Vermeer MV Solutions, Inc.

FIELD CAMPAIGN KIT #: VMV000015 **DATE:** 6 January 2022

For Dealer Reference: Service Bulletin #: SMV2022-003

Operator's/Maintenance Manual Lug Nut Torque Value Update Kit

Procedure 1: Replacement of tethered Teslin manual

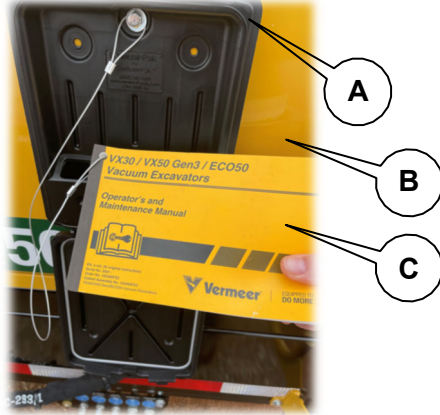
1. Locate manual box (A) on enclosure door (B). Open manual box (A) to reveal existing tethered Teslin manual (C).

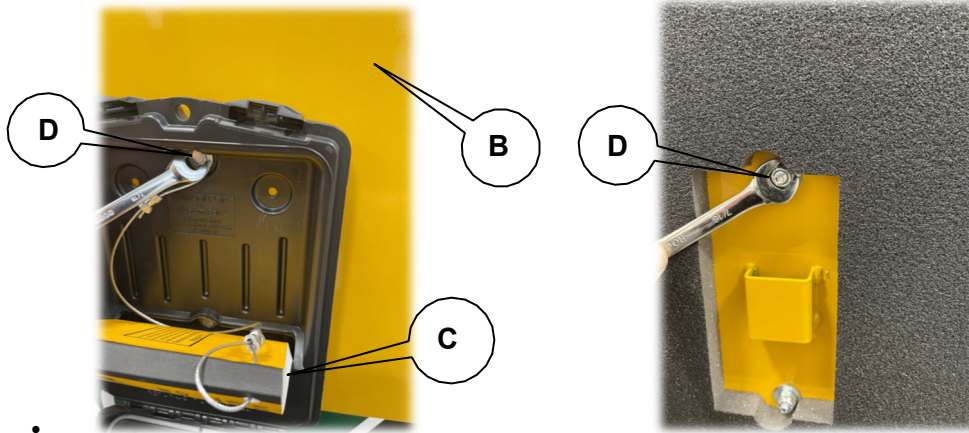
2. Open enclosure door (B) and using two 7/16-in wrenches (not included) loosen (not remove) bolt set (D) holding existing tethered manual (C).

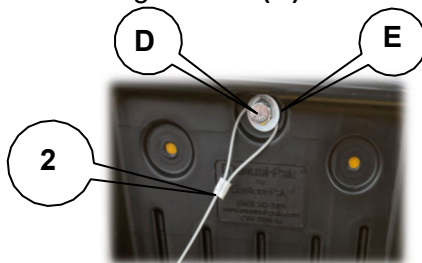
3. Remove existing tethered manual and discard.
4. Install new tethered manual (2) by placing the loop behind the existing washer (E) and tightening the existing bolt set (D).

5. Place new Teslin tethered manual (2) in existing box.
